River Bend Station - Unit 1

Docket No. 50-458

Provided below for your review is Gulf States Utilities Company (GSU) response to Request for Additional Information identified by the Nuclear Regulatory Commission's Instrumentation and Control Systems Branch (ICSB). This letter will provide final close out to Confirmatory Item (33) of Table 1.4 of the Safety Evaluation Report.

Fig-1

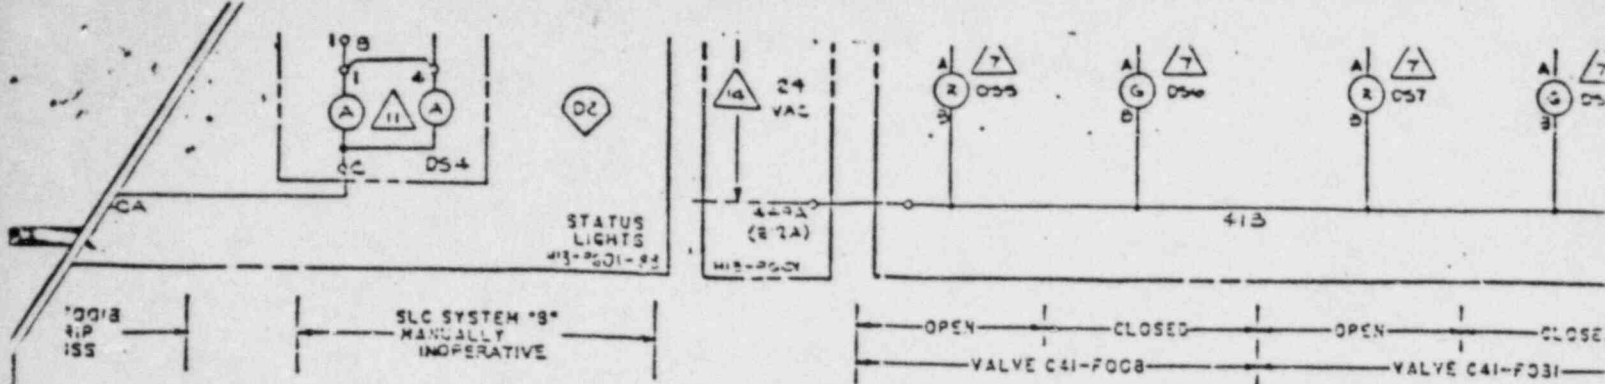
The ICSB has requested information to confirm that sufficient standby liquid control system (SLCS) inoperable status indication is provided. GSU will install an additional annunciator "C41-F031 valve not fully closed" for the SLCS test tank suction valve (see Enclosure 1).

SLC SYSTEM A & B
INOP. F031 NOT
FULLY CLOSED.

Fig-2

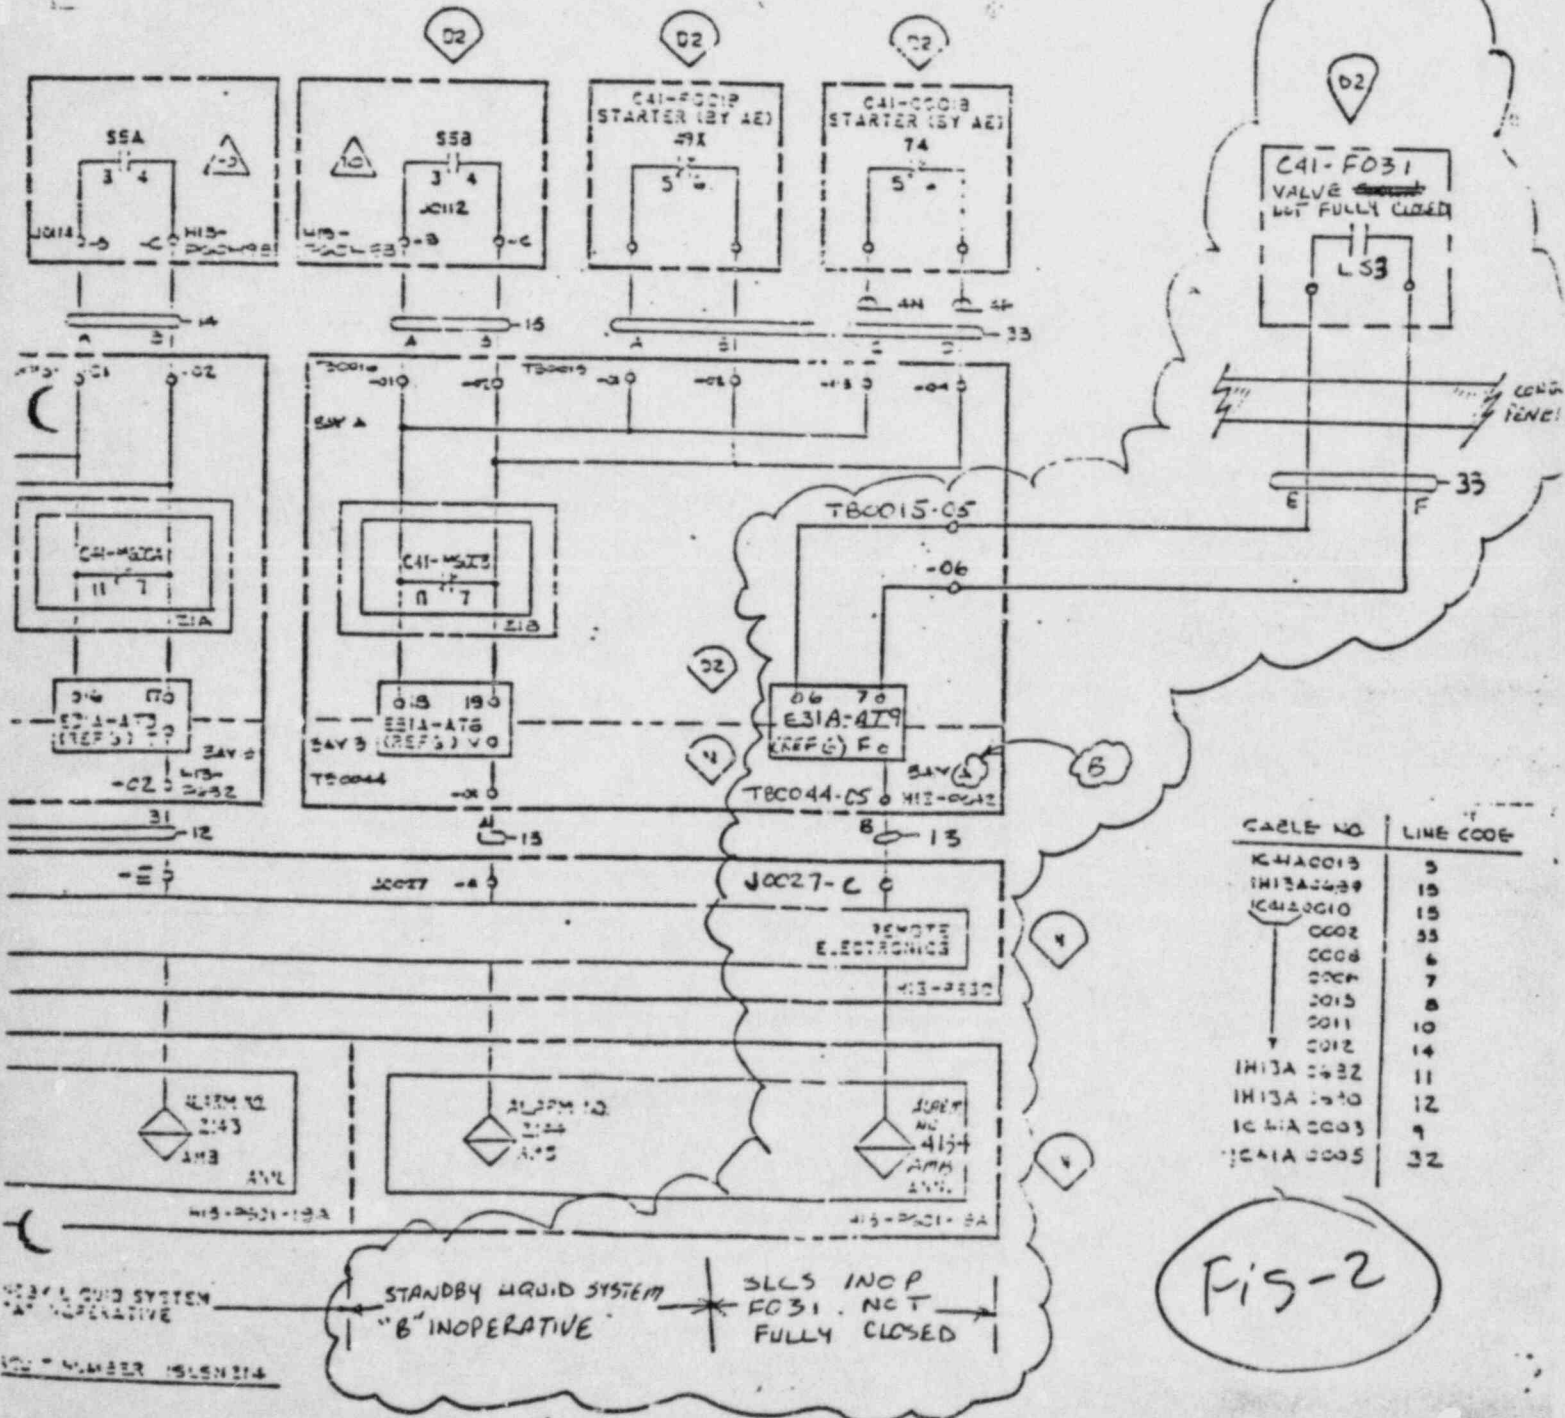
~~F008 LDI 2484~~
 REV. 7
 SH. 7
 ADD
